Glasfaser-Flugzeug-Service GmbH Hansjörg Streifeneder Hofener Weg 72582 Grabenstetten	Technical Note No. 303-23 No. 304-10	Page: 01/ 02 F.R.G. Type Certificate No. 318
Subject:	Rudder gimbal drive -rear actuator arm-	
Affected:	Sailplane model „Mosquito“ F.R.G. Type Certificate No. 318 Sailplane model „Mosquito b“ F.R.G. Type Certificate No. 318 Sailplane model „Glasflügel 304“ F.R.G. Type Certificate No. 318 does not include Glasflügel 304 b and Glasflügel 304 cz	
Urgency:	The actuator arm must be replaced not later than March 31 st ,2003	
Reason:	Failure of the actuator arm caused by loads applied when regularly lifting the fuselage by ist rudder and/or when fuselage has broken.	
Actions:	<p>The faulty part, made according to drawing No. 203-45-10, must be replaced by an improved actuator arm, made in accordance with drawing No. 203-45-10-2</p> <p>Working instructions:</p> <ol style="list-style-type: none"> 1. Remove rudder by removing the M4 bolt securing the actuator arm to the rudder (located in a cavity at the lower end) 2. Remove horizontal axle from gimbal drive by removing the castellated nut. 3. Remove both castellated nuts from rudder actuator arm and pull mounting bolts

Ruderlenker

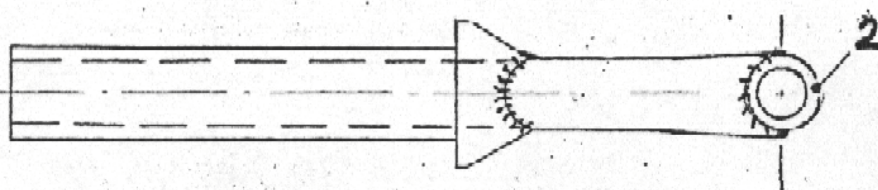
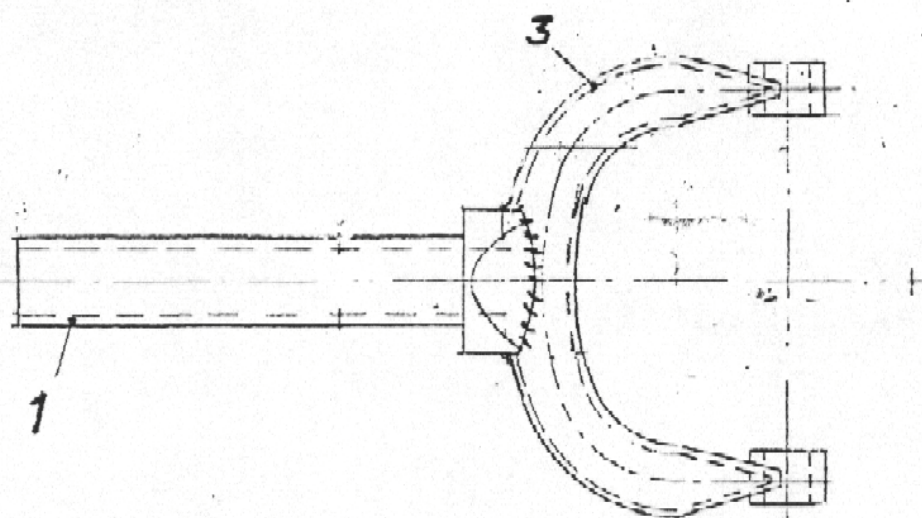
Actions (cld.)	<p>6. Re-attach rudder with the flange bushing and tape it to fin when in proper position to avoid any aft movement.</p> <p>7. Secure the flange bushing on the actuator arm in position by a wedge placed between bushing and cavity wall. Make sure that the bushing's 4mm holes are horizontal. Punch mark actuator arm on both sides at the center of the bushing's 4.0 mm holes and drill arm to a diameter of 2.0 mm. With these holes properly aligned, drill to a diameter of 3.8 mm, then ream to 4.0 mm. If the 2.0 mm holes are not aligned, it is possible to use a round needle file for centering, then drill and ream to proper diameter.</p> <p>8. Insert locking bolt and secure with M4 stop nut.</p>
Material:	<p>1 off rudder actuator arm made according to drawing 203-45-10-2 1 off M4 stop nut 3 off Split pins, 1.5 x 16 mm</p>
Note:	<p>Replacing the actuator arm must be done by Hansjörg Streifeneder Glasfaser-Flugzeug-Service GmbH only or by an approved repair station. Only genuine parts made in accordance with drawing No. 203-45-10-2 must be used. Proper accomplishment of the action must be entered into the sailplane" log book by a licensed inspector.</p> <p>Supply source: Hansjörg Streifeneder Glasfaser-Flugzeug-Service GmbH Hofener Weg D-72582 Grabenstetten Germany</p> <p>Weight: Difference negligible</p> <p>c/q position: Difference negligible</p>
